Safety Recall

Code: 1902

Audi

Subject	After-Run Coolant Pump																		
Release Date	April 26, 2019																		
REVISION SUMMARY	Claiming and work instructions have been updated to allow the “K” or “H” index after-run coolant pump for Criteria 05 and 06 vehicles.																		
Affected Vehicles	<p>U.S.A.: Certain 2012-2017 MY Audi vehicles with a 2.0L TFSI gasoline engine</p> <p>CANADA: Certain 2013-2017 MY Audi vehicles with a 2.0L TFSI gasoline engine</p> <p><i>Check Campaigns/Actions screen in Elsa on the day of repair to verify that a VIN qualifies for repair under this action. Elsa is the <u>only</u> valid campaign inquiry & verification source.</i></p> <ul style="list-style-type: none"> ✓ Campaign status must show “open.” ✓ If Elsa shows other open action(s), inform your customer so that the work can also be completed at the same time the vehicle is in the workshop for this campaign. 																		
Problem Description	In certain vehicles with a 2.0L TFSI gasoline engine, the electric (after-run) coolant pump may short circuit and/or overheat, potentially leading to a vehicle fire.																		
Corrective Action	Install a new electric (after-run) c

Installing new after-run coolant pump -V51-

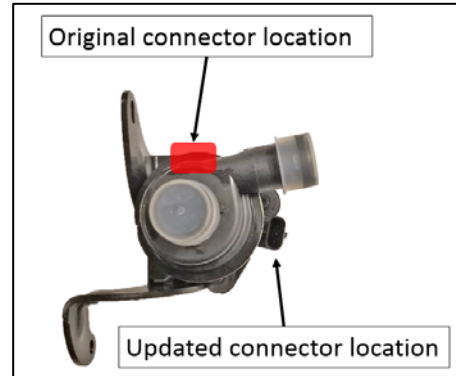
Due to the new location of the connector on the new pumps, the after-run coolant pump wiring harness <arrow> may have to be routed so it does not come into contact with the pump coolant hose.
